# Service Bulletin

Bulletin No.: PI0690A

**Subject:** MIL Illuminated, DTCs P0961, P0965, P0969, P2762 and Battery Has Been Relocated

**Models:** 2010-2012 Chevrolet Express  
2010-2012 GMC Savana  
Equipped with 6L90 Automatic Transmission (RPO MYD)

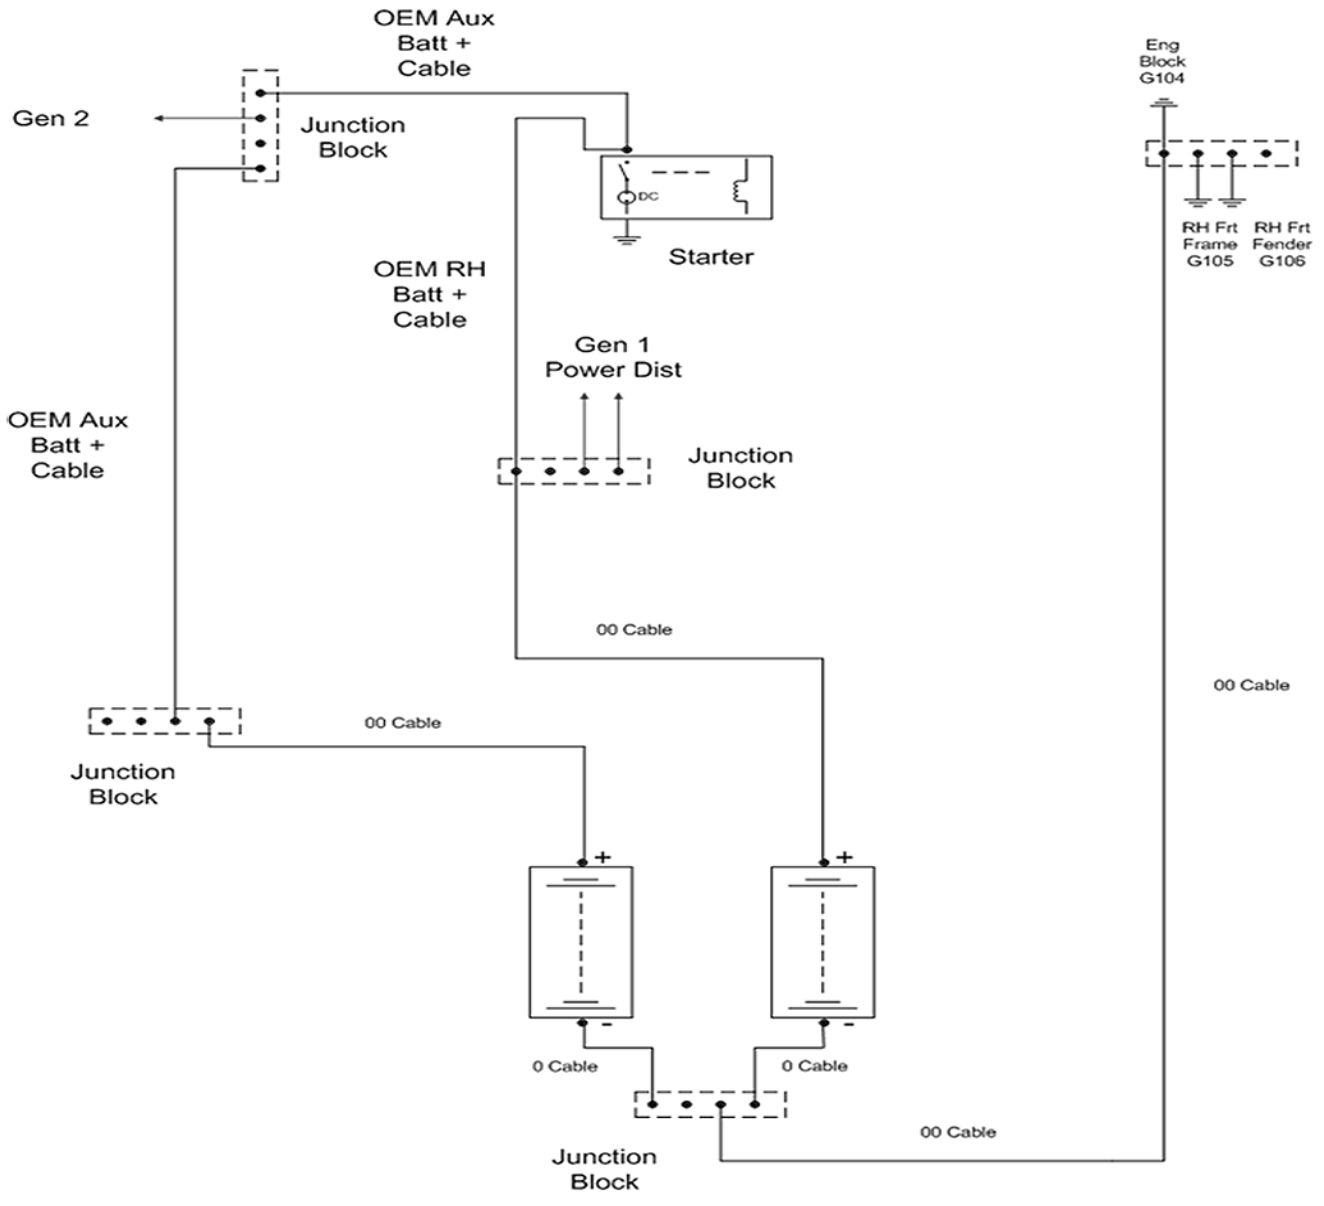
These transmission DTCs are likely the result of improper battery grounding.

Inspect the vehicle for the location of the battery. If the battery has been removed from the underhood location and relocated, inspect the battery ground.

Grounding cannot be done through the frame rail. The battery must be grounded directly to the engine.

Proper battery grounding must be re-established by either relocating the battery to the original underhood location or by modifying the remote battery ground wiring.

Relocate the battery to the OE underhood location and re-establish the original power and ground connections for both the battery, ground cable and power cable.

Revise battery grounding following these steps:

1. Remove any ground connections between the battery/batteries and the frame rail.
2. Install an isolated ground stud underhood at or near the original battery location.
3. Install new, 00 Gage or larger ground cable from the remote battery/batteries to the new, isolated ground stud underhood.
4. Connect the original, underhood battery ground cable to the new isolated ground stud. Ensure that all original ground cable connections (G104, G105, G106) are secure. Or, connect new 0 Gage or larger ground cable from the new isolated ground stud to G104, G105 and G106 ground locations. Refer to SI Master Electrical Component List for the location of these ground points.
5. Ensure that G103 at the rear of the LH engine head has a clean and tight connection.
